RE: Pitre KIA – Site Plan EPC

CONDITIONS OF APPROVAL-PR-2024-011052, SI-2024-01468 – Major Amendment to Site Plan – EPC

Per the conditions of approval dated November 21st, 2024, please find the following responses addressing the comments listed below:

ARCHITECTURAL SITE PLAN

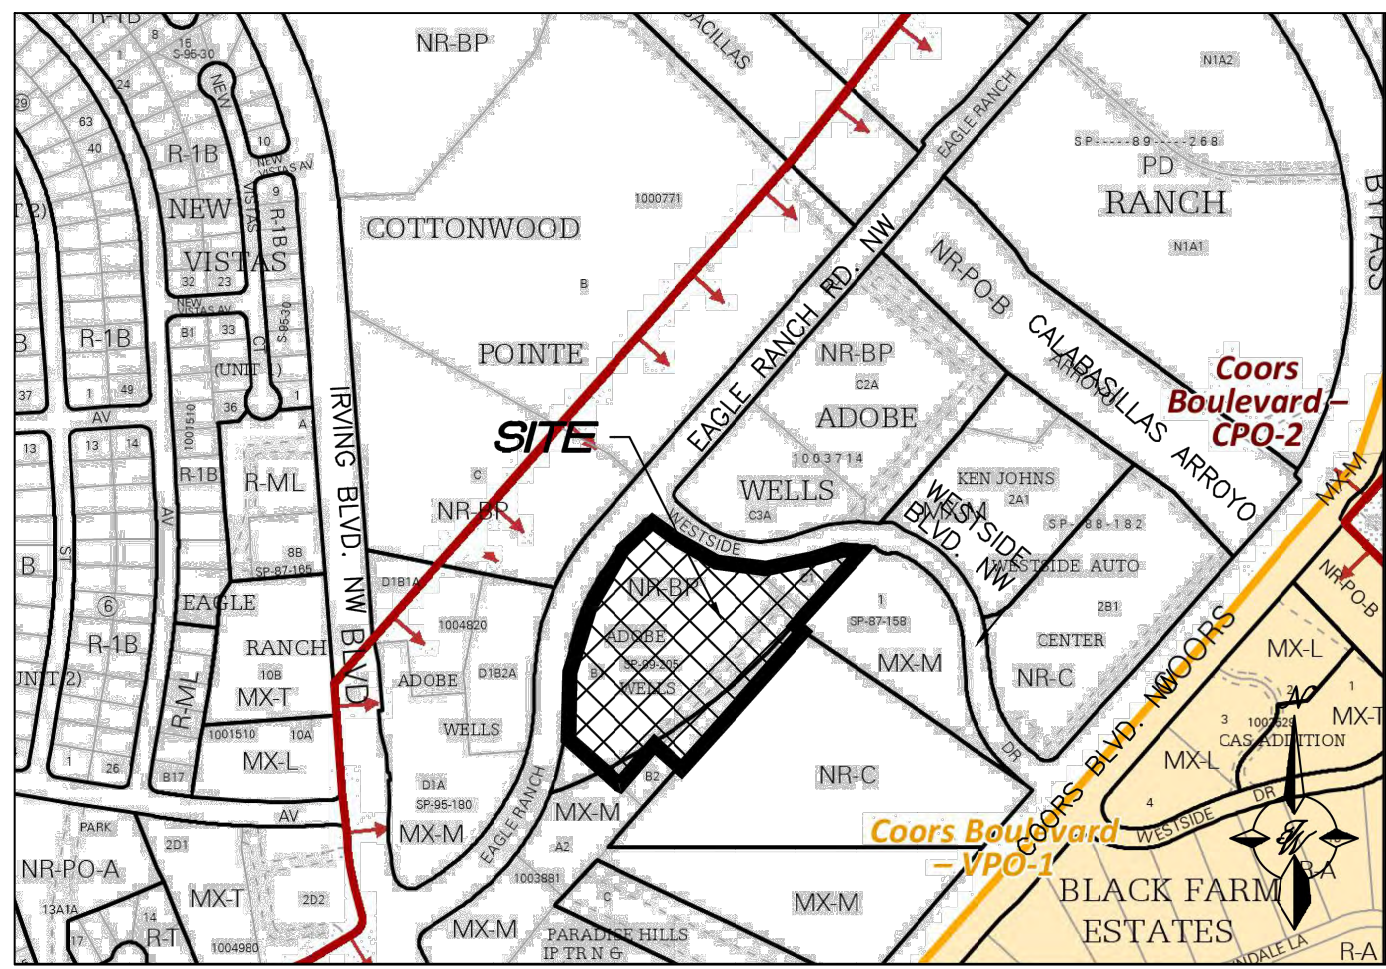
A. Add the legal description to this sheet.

B. The Site Plan shall comply with the General Regulations of the IDO and all other applicable design regulations, except as specifically approved by the EPC.

Applicant Response: Updated Site Plan with legal description attached to this letter.

Applicant Response: Updated Site Plan including the general note, “The Site Plan shall comply with the General Regulations of the IDO and all other applicable design regulations, except as specifically approved by the EPC.”

**Landscape Plan
(Existing)**

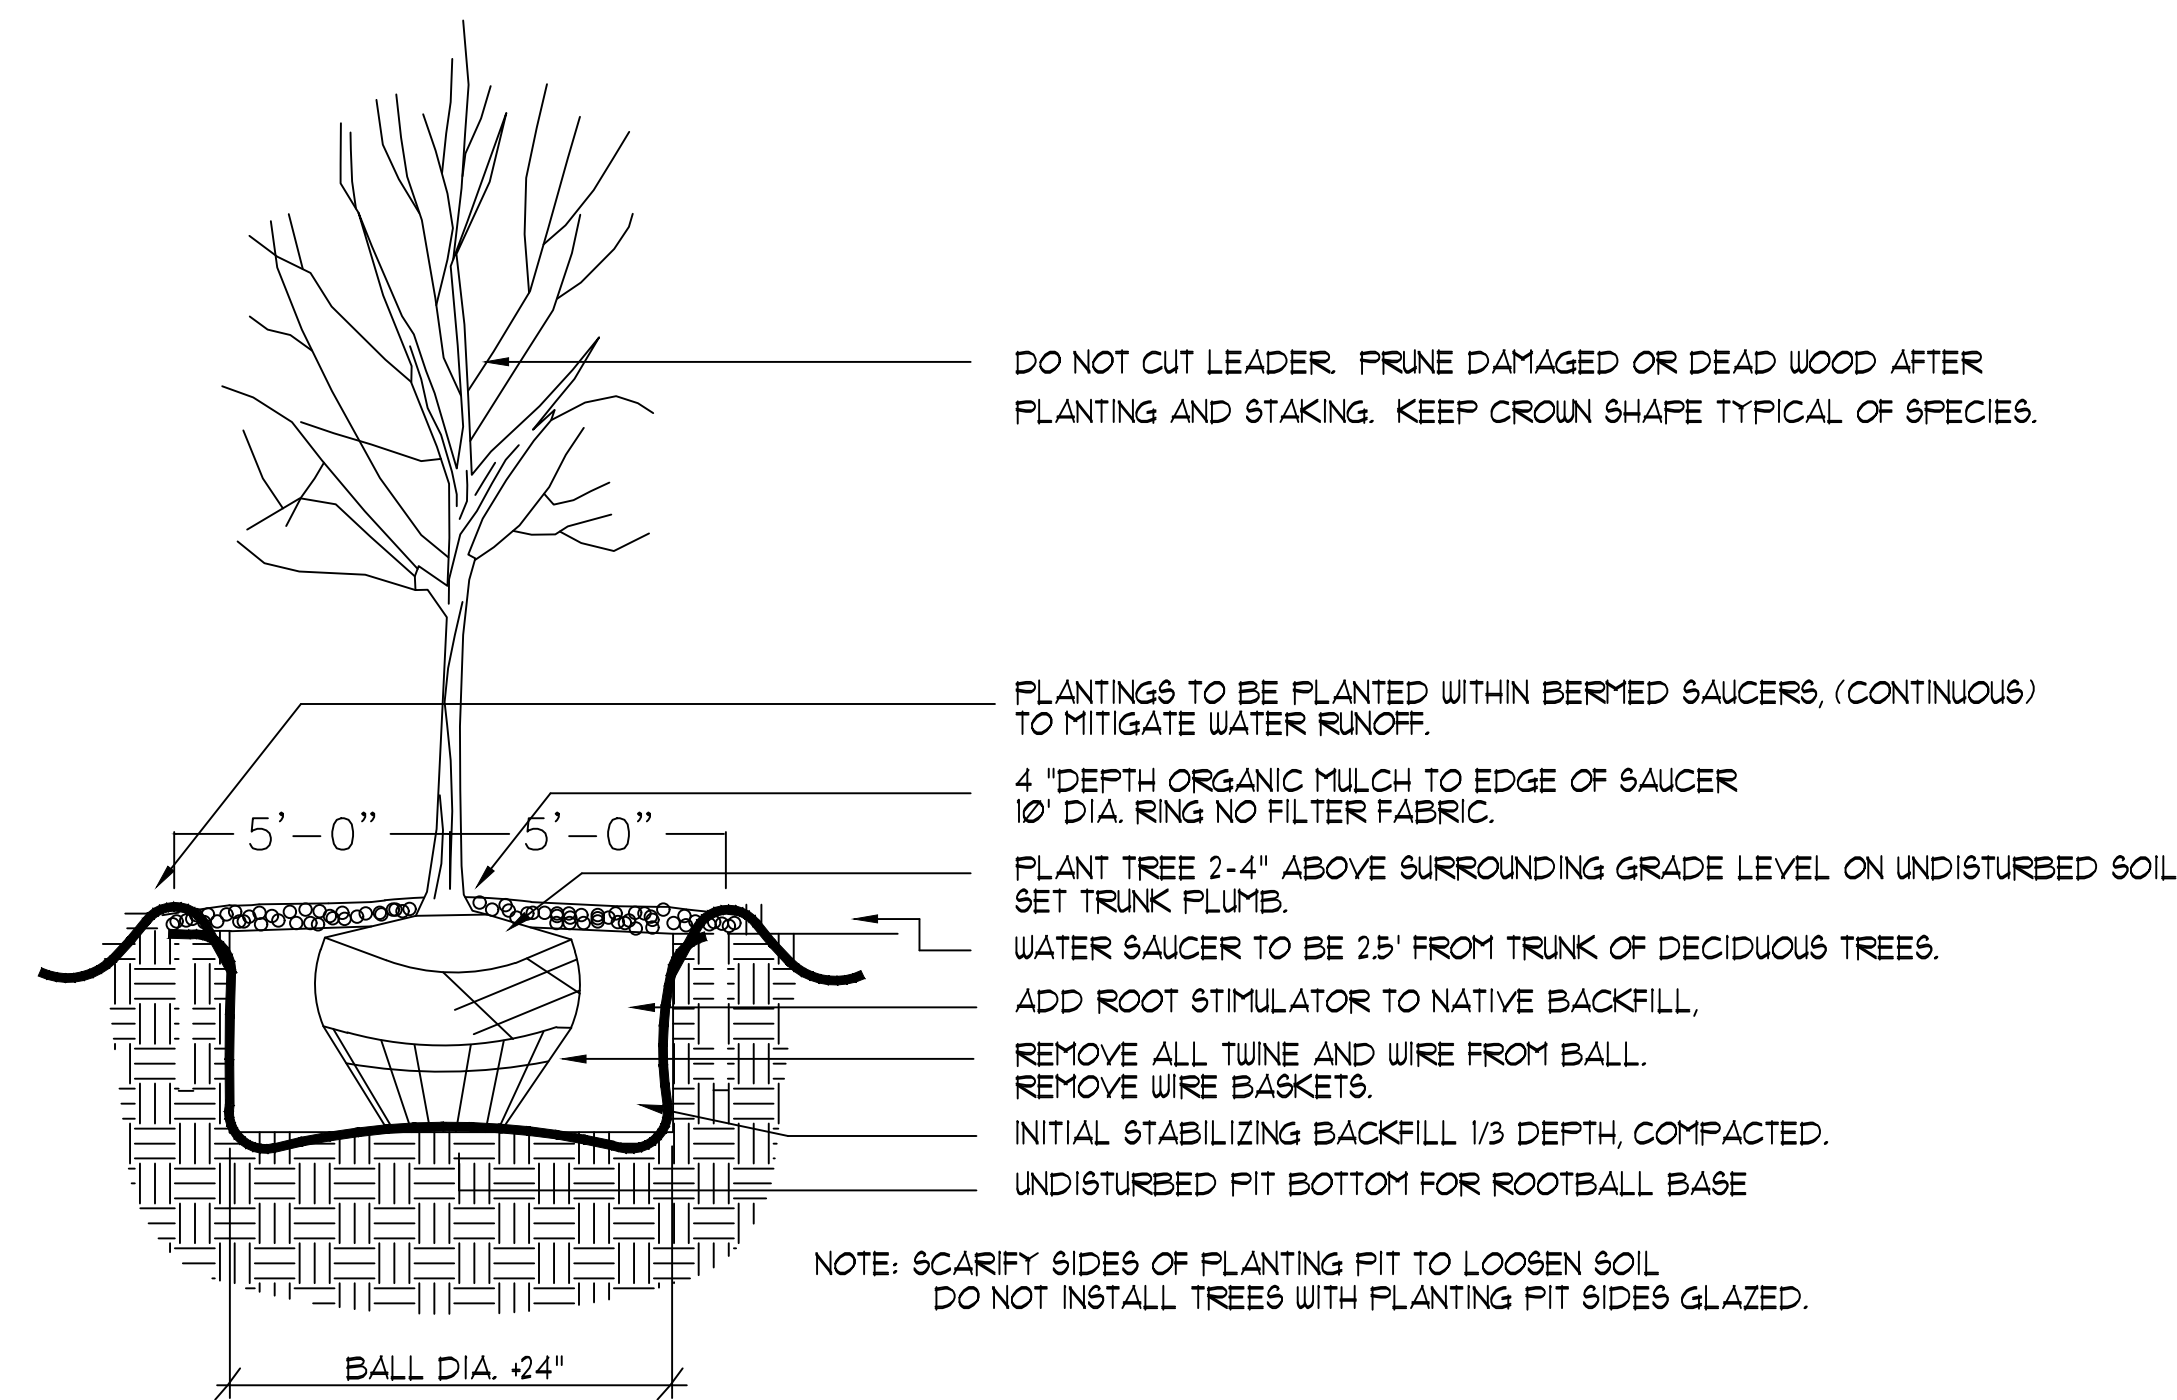
- Landscape Plan shall be stamped and signed by a licensed Landscape Architect.
- Revise the Landscape Plan to clearly show what is existing and what is to remain.
- Per Street Tree Ordinance 6-6-2-4 REQUIRED STREET TREES (1) All applicants for building permits for construction of a new building or building addition of 200 square feet or more shall submit a street tree plan for those parts of the lot abutting a major street, a major local street, or another street where street trees are required.
- Show street trees 25 feet on center along Westside Boulevard.
- Revise the Landscape Plan to select a tree species other than ash trees, which are overplanted and struggling in current climate conditions.
- Work with Urban Forestry to revise the Landscape Plan to identify the shrubs to be replaced and maintained.

A. The asphalt paving limits shall be modified to accurately show the new paving limits around the proposed addition.

B. The new plantings on the southeast corner of the proposed addition shall be identified.

Applicant Response: Updated Landscape Plan stamped and signed by a licensed Landscape Architect is attached to this letter. Plan addressed the various comments iterated above from the CABQ Parks and Rec. Urban Forestry.

Applicant Response: Updated Landscape Plans stamped and signed by a licensed Landscape Architect is attached to this letter. Plan identifies the limits of the new paving around the proposed addition and details the plantings on the southeast corner of addition accordingly.

EAST ELEVATION
1/A2.1

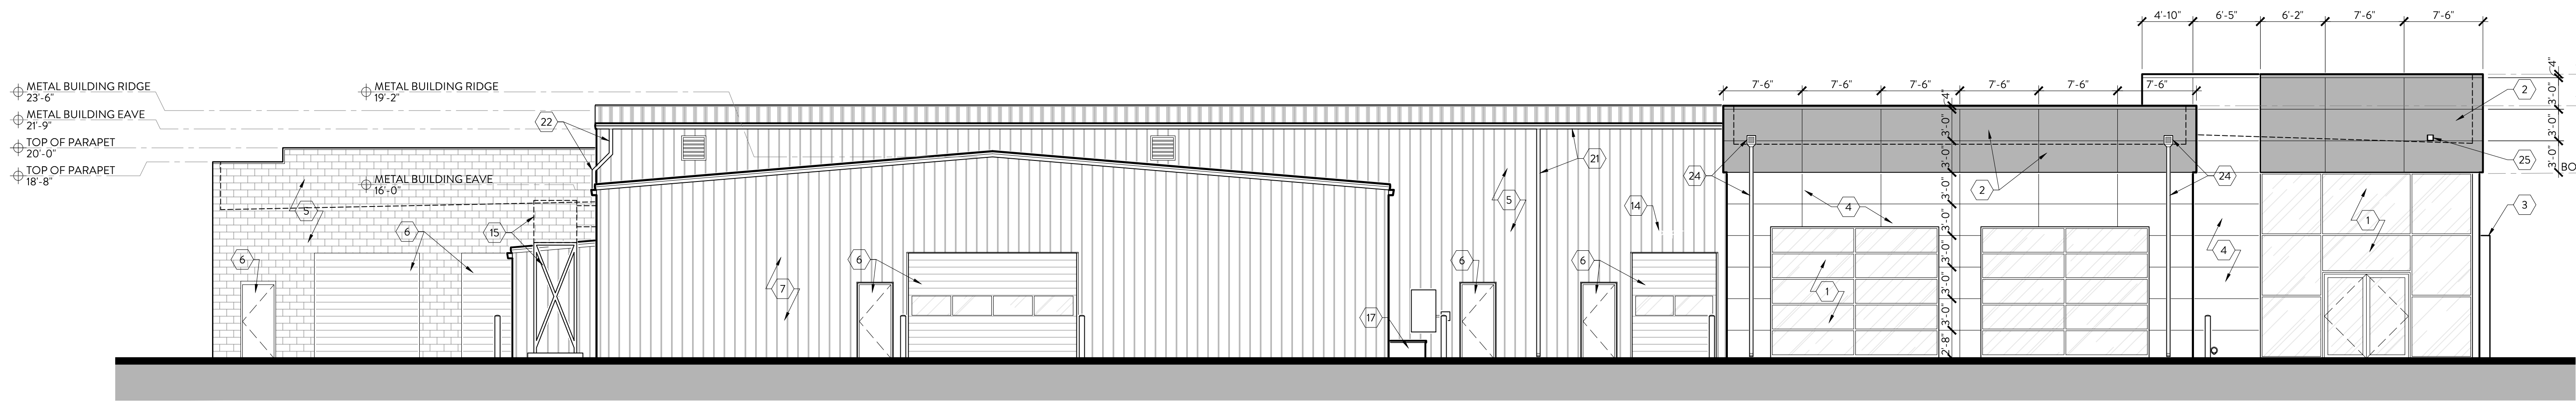
A. The missing "Parts" sign on the East (Side) Elevation for Keyed Note #14 shall be added to the sheet.

Applicant Response: Updated Elevation Sheet is attached to this letter, addressing the comments referenced above.

NORTH ELEVATION
2/A2.1

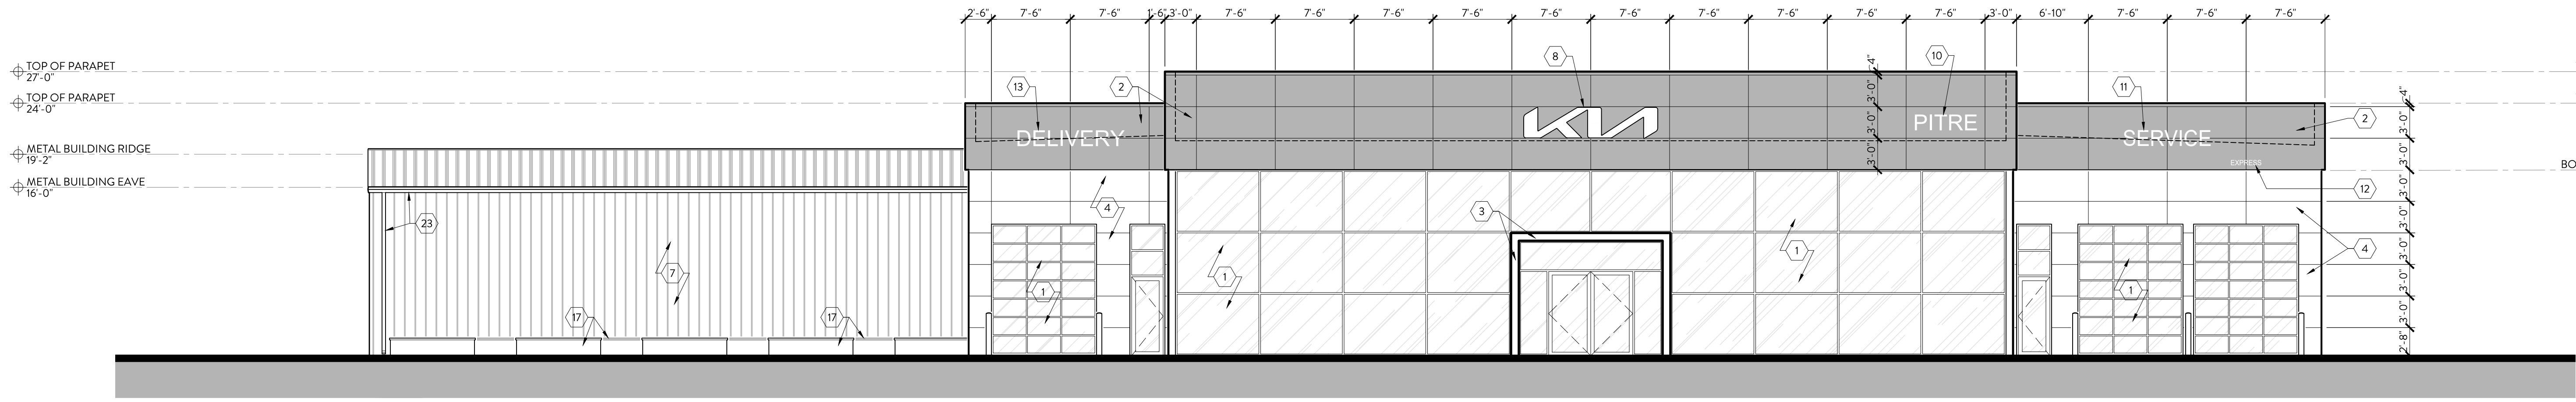
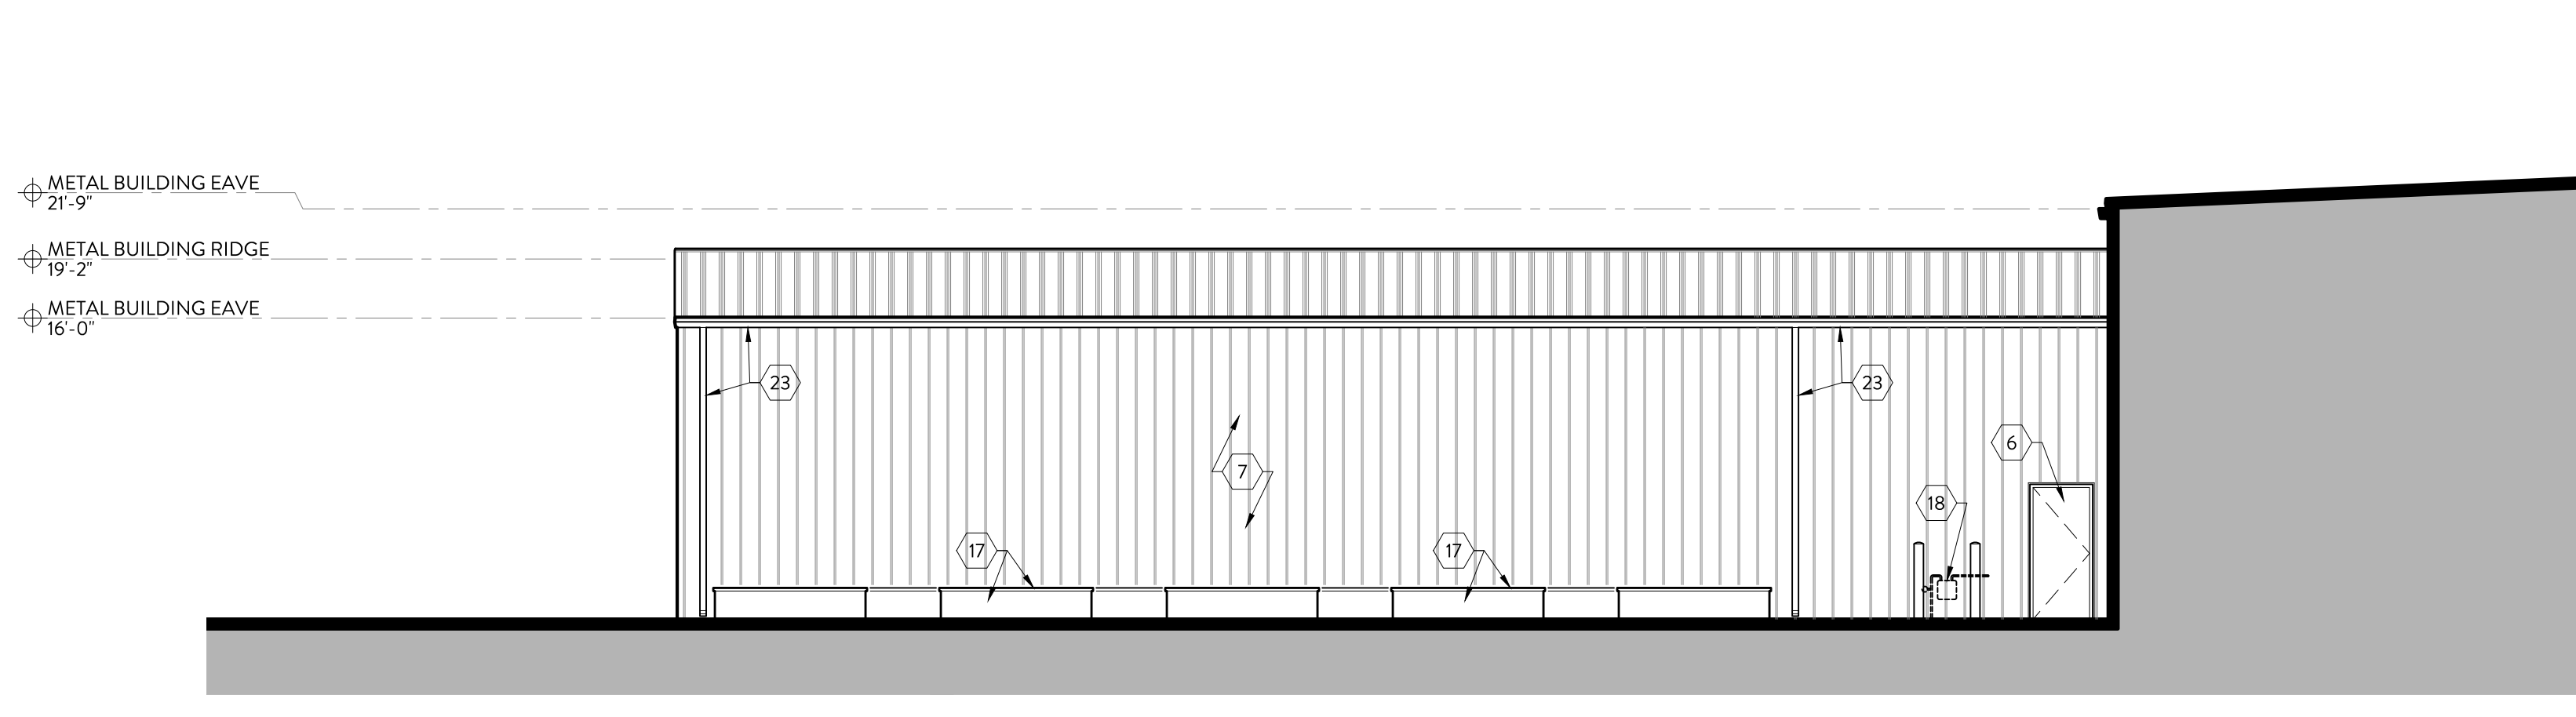
B. The North (Front) Elevation of the proposed addition with the 57'-0" façade shall incorporate 1 required feature every 40'-0" to adhere to the required total of 2 features along 30 percent of the length of the façade pursuant to §14-16-5-11(E)(2)(a)-(g).
